Preferred Project Report and Statement of Commitments

Darling Walk, Darling Harbour Bulk Excavation, Basement Structure and Construction of Buildings

Submitted to
Department of Planning
On Behalf of Lend Lease Development

November 2008 ■ 08517

Figure 1 – Development footprint, proposed buildings and setbacks

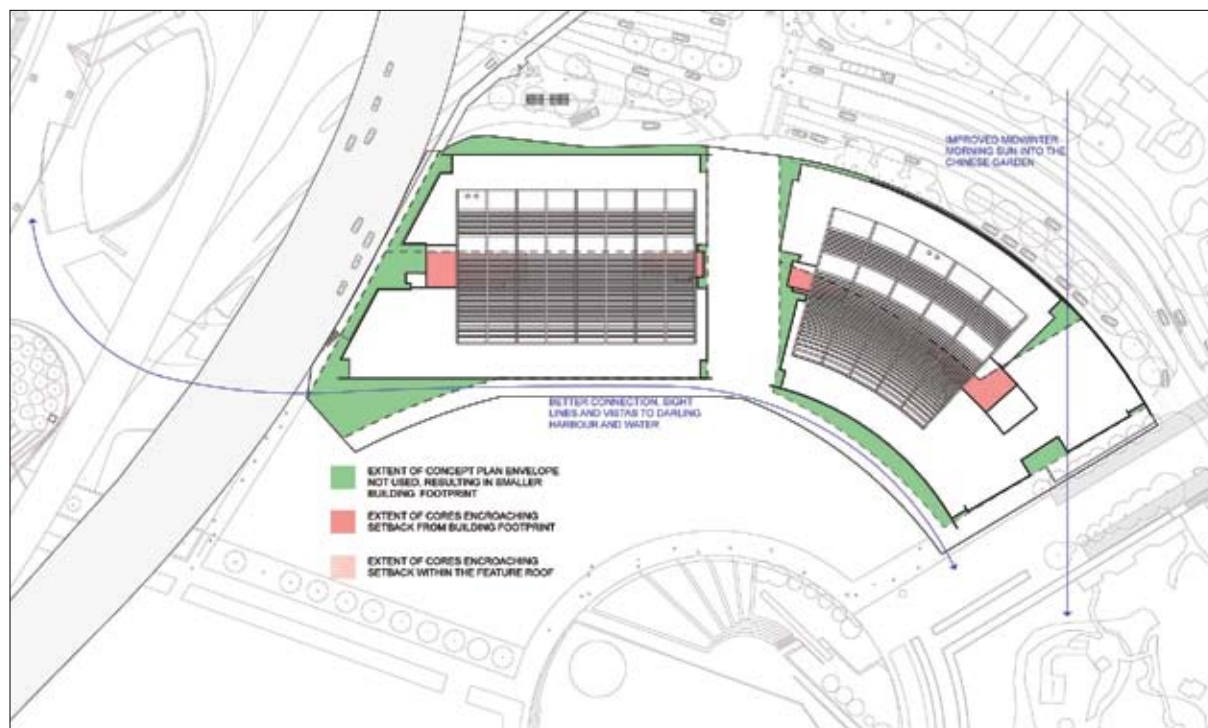
City of Sydney Council in particular raised issues regarding:

- interface with Harbour Street and provision of a series of ground level pedestrian entry points;
- relocation of service areas to maximise active uses on Harbour Street; and
- provision of a direct pedestrian link from Liverpool Street bridge into the internal atrium;

As illustrated in **Figure 1**, the proposed buildings do not occupy the full extent of the building envelope on the ground plane approved by the Concept Plan. As detailed in the EAR the north west edge of the building has been re-aligned to help achieve an improved physical and visual connection between Darling Walk and the Cockle Bay precinct to the north. At the south eastern corner a greater setback than the approved Concept Plan allows midwinter sun into the Chinese Garden. As the building has not been built out to the maximum envelope allowed under the Concept Plan there is less overshadowing than the approved Concept Plan.

The development will significantly improve the interface with Harbour Street by providing active uses including building lobbies and retail space. In particular the Civic Connector is a major new urban connection delivering a new at-grade entry to Darling Harbour. The link establishes a pedestrian extension of Day Street across Harbour Street into the Darling Harbour public domain. The Civic Connector will be activated by retail uses at the western end and by the commercial building lobbies at the Harbour Street end. The building lobbies, retail spaces and Civic Connector provide a series of ground level pedestrian entry points. New landscaping works and public domain improvements along Harbour Street will also improve pedestrian amenity. The activation of the ground plane is illustrated at **Figure 2**.

The north end has been activated by introducing a new stair and lift from the pedestrian bridge which will bring pedestrians to the northern end on Harbour Street. The majority of pedestrian movements at this corner will be on Level 1 where the pedestrian bridge across Harbour Street connects with the building. The service area at the northern end of Harbour Street is past the car park entry and required for the building plant and equipment. The location of service plant at this corner is the most practical for building function and it is not possible to relocate it within the building.

Figure 4 – Cross Section with Vaulted Roof

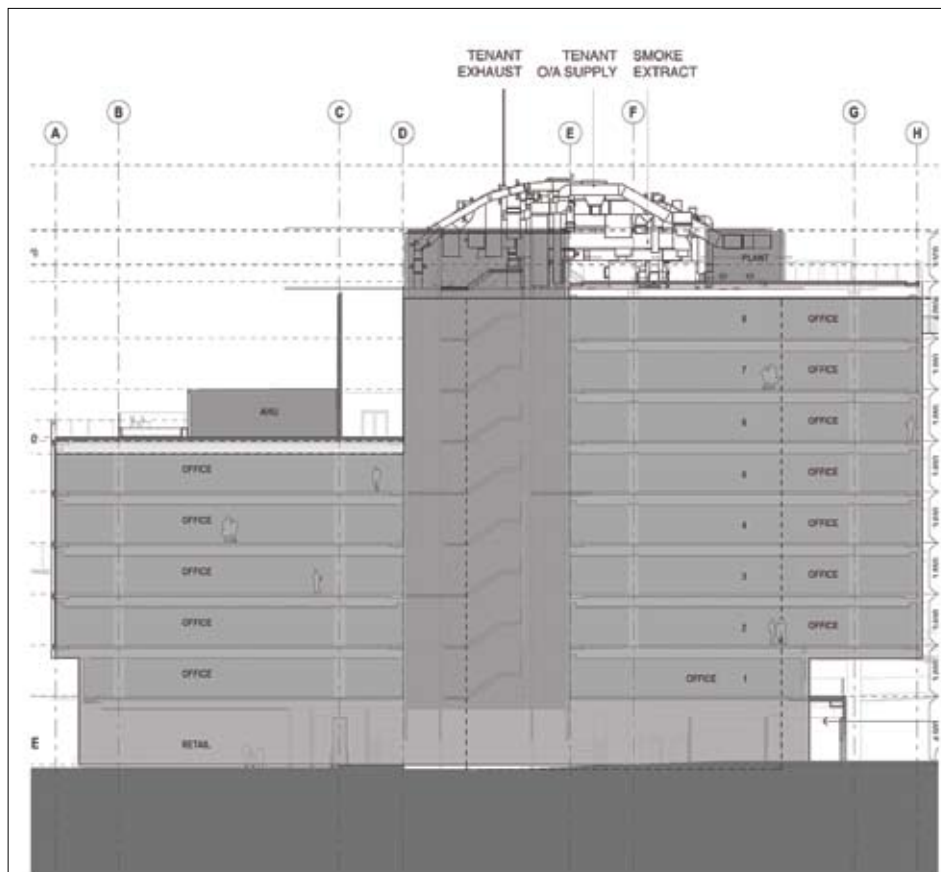
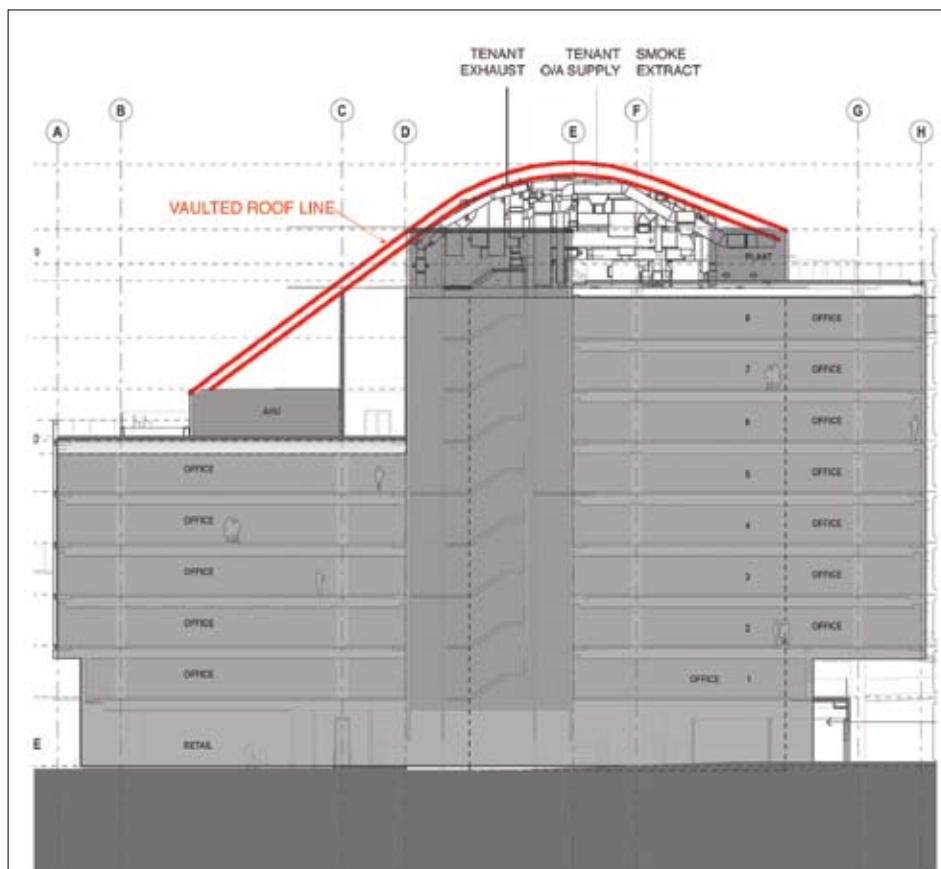
The Department of Planning has sought further detail and justification on the scale and height of the architectural roof and the potential additional impact on views. Impacts on views are addressed at Section 2.2.

The Concept Plan allows for architectural roof forms and parapets above the envelope. The roof has been designed to integrate the eastern and western sides of each building and to provide roofing over the atrium and a visual solution to the otherwise exposed mechanical plant, whilst maintaining appropriate heights and scale.

In response to issues raised, FJMT have reviewed design options for the roof form. A key design of the roof is the incorporation of plant and equipment such as cooling towers, air handling units and the like under its profile. Detailed analysis of the plant requirements has been undertaken and as far as possible the plant has been distributed between the basement, ground floor, Level 6 and Level 9, however there are constraints due to existing below ground services and the required energy efficiencies of a 5 star ABGR building.

As illustrated in **Figures 3 and 4** the vaulted roofs sits directly above the plant.

Figure 6 – Horizon view Impact

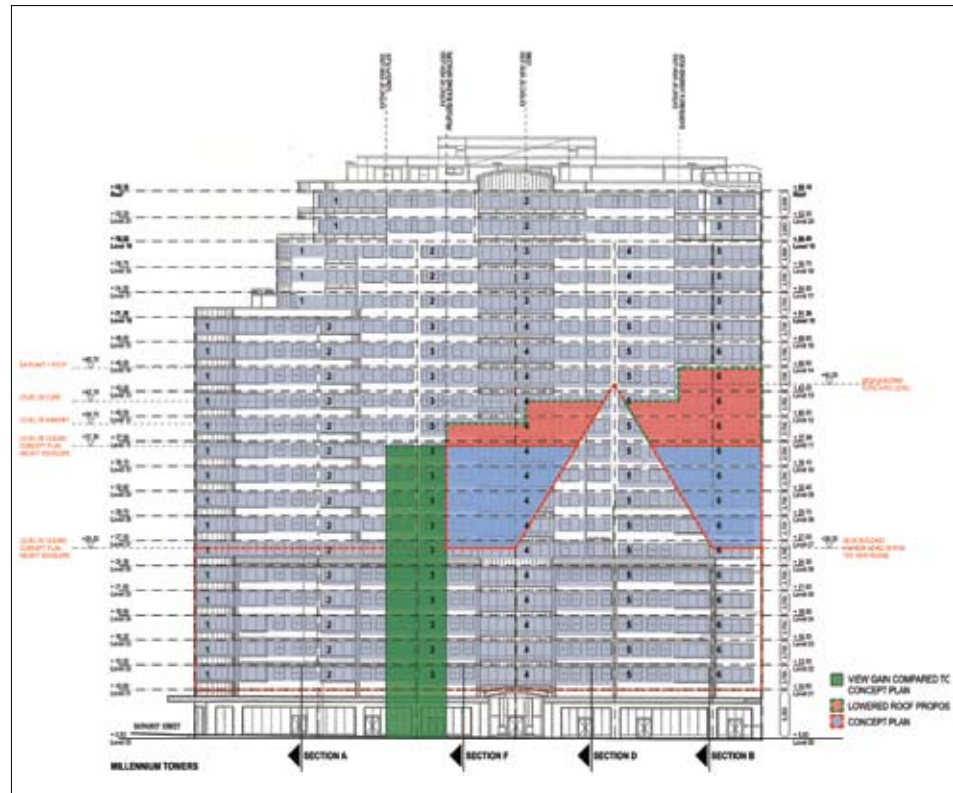
Three submissions raised the issue of loss of view from residential apartments including Millennium Towers, Emporio Apartments and Harbour Gardens. In addition the Department of Planning sought further information on the visual impact of the proposed roof.

The impact on views from apartments in Millennium Towers, in total, does not increase as a result of the roof structure. The FJMT analysis shows that in relation to view loss into the centre of Tumbalong Park for the amended (lowered and shortened roof) the net number of apartments affected is reduced by one when compared to the Concept Plan as detailed in **Table 1**.

Of the 38 apartments affected, 11 lose views to the centre of Tumbalong Park and 27 suffer horizon view loss to Pyrmont Ridge. However, 18 apartments gain new views to Tumbalong Park and Pyrmont Ridge. Whilst some additional apartments will suffer some loss of horizon views to Pyrmont Ridge, other apartments gain views and therefore the addition of the roof and plant does not result in an increase in the total number of apartments with affected views.

The impact on views is illustrated at **Figures 5** and **6** and in the Visual Analysis Report at **Appendix B**. The red shaded area illustrates view loss due to the detailed built form, green shaded area shows views gained and the blue shaded area shows view impacts of the approved Concept Plan envelopes.

Figure 10 – Section of the walkway on the north elevation

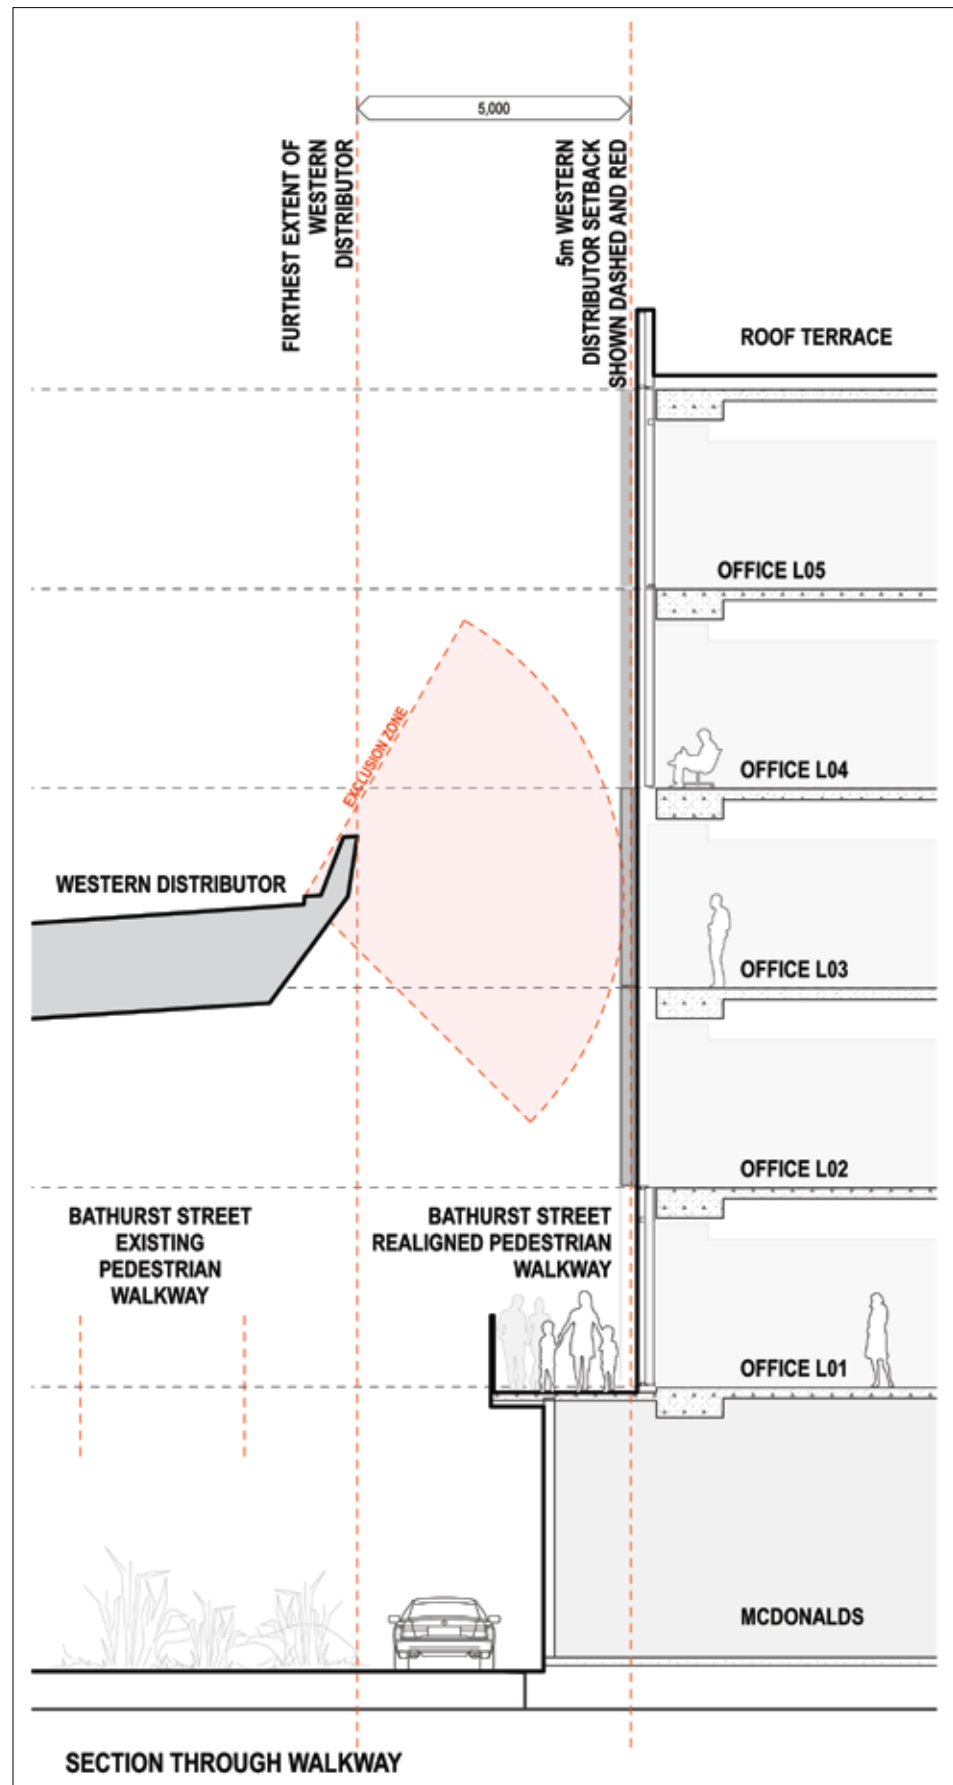
The Department of Planning requested further information on upgrades of the Bathurst Street Pedestrian Bridge. The Darling Walk redevelopment seeks to improve pedestrian amenity through the design of an activated frontage along the Harbour Street that is welcoming to pedestrians from Day Street. In addition, the development will augment the existing Bathurst Street Pedestrian Bridge to encourage pedestrian use.

- A new canopy over the length of the bridge over Harbour Street that will:
 - Protect pedestrians from sun and rain.
 - Promote and facilitate safe and convenient connections between Day Street, Darling Walk and Tumbalong Park.
 - Promote safety by maintaining clear lines of sight along the length of the bridge and by incorporating lighting and architectural elements to provide an interesting pedestrian and visual experience.
 - Be a lightweight structure (subject to structural loads).

- Realignment of the existing footbridge at the western end so that it integrates with the new development by connecting both onto the podium at the North of development, along the Western distributor, as well as connecting to the North building itself via a colonnade extending from the footbridge at the eastern side of the building to the Civic Connector. The extent of the footbridge along the Western Distributor will be uncovered to enhance visibility and security.
- Integration with the Civic Connector via stairs and lift access on the western side of Harbour Street. This facilitates the safe and comfortable movement of pedestrians between Day Street and Darling Harbour.
- Proposed works will be undertaken to provide equitable access in compliance with the relevant Australian Standards.

Figure 8 is a diagrammatic plan of the bridge augmentation and **Figure 9** is a section of the walkway on the north elevation. These drawings are also included at **Appendix H**.
